Tech Tip

From your friends at New York Bus Sales

Product Effected – Blue Bird Type C&D

Complaint - The unit appears to have a fuel leak at the tank -

Figure #1

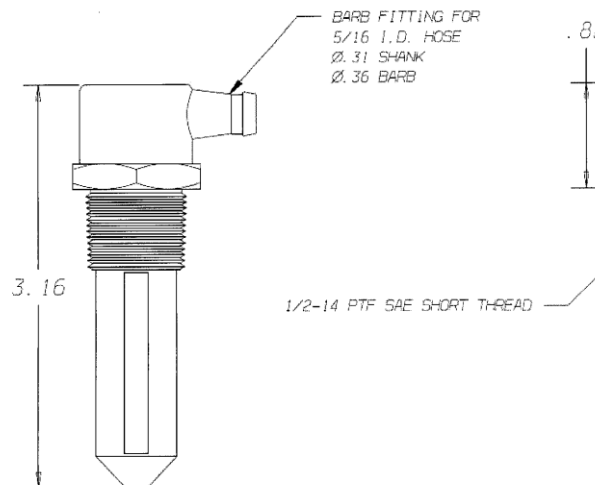
There was a new style vent that was used in production which is pictured in Figure #1, this vent contacts fuel at a lower level than the first production vent which is shown in Figure #2. If you look at the design of the tank, especially those “mid-mounted” in the frame even if the “first-click” method is used in fueling the tank it will allow the tank to take on more fuel as there is a 2-1/2” fuel fill line from the tank to the fuel fill which needs to be filled with fuel before it will “clock off”.

This higher level also causes the tank to allow fuel to be released from the vent line which would appear as a fuel leak.

Correction Once you are sure this is the location of the leak you should pull the vent and inspect. The “new” style vent should be replaced with the “old” style vent. In changing the vents you are raising the fuel contact point of the vent which if the first click method is used will cause no problems with a vent line leak.
